# 1964 Corvette: Engineering Service Letter: Increased Capacity Fuel Pump

**Subject:** Increased Capacity Fuel Pump

**Model and Year:** 1964 Corvette 365 - 375 HP Engine And/Or Air Conditioning

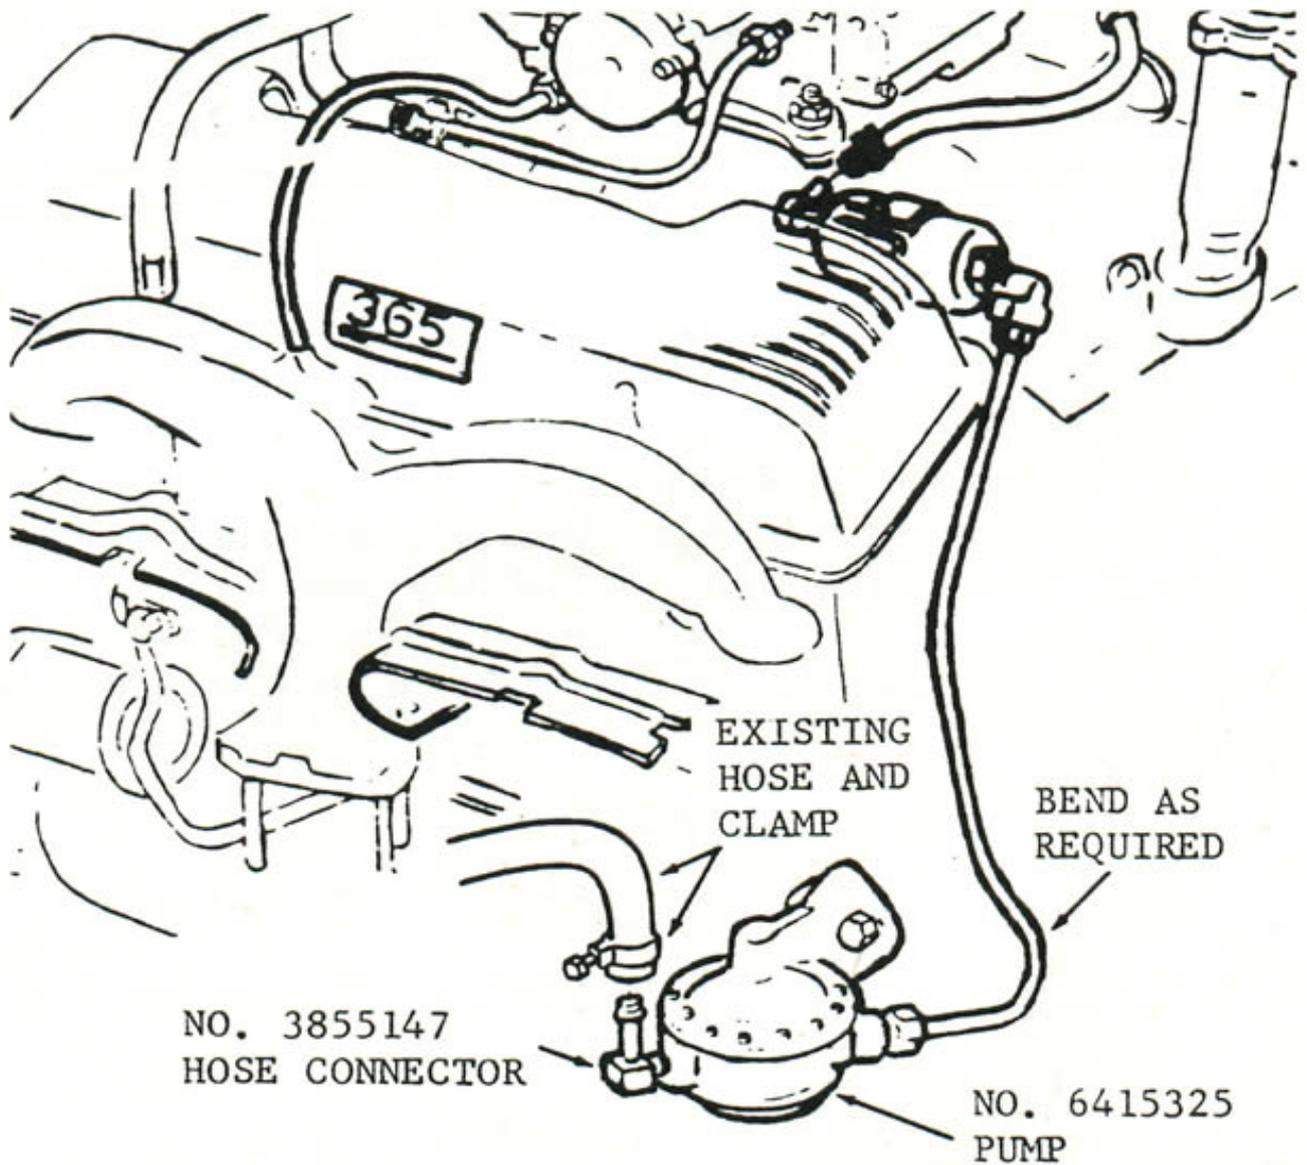
Corvettes with high performance engine options and/or air conditioning may experience a fuel vapor lock condition during high ambient temperatures. To eliminate this possibility, a new high capacity fuel pump is used on late production units with the subject options. The new high capacity pump includes vapor bleed holes in the inlet and outlet valves.

To install the new design pump on early production Corvettes, replace the existing pump with part number 6415325 Pump and part number 3855147 hose connector elbow. Bend the existing gas line as required to match the outlet fitting.
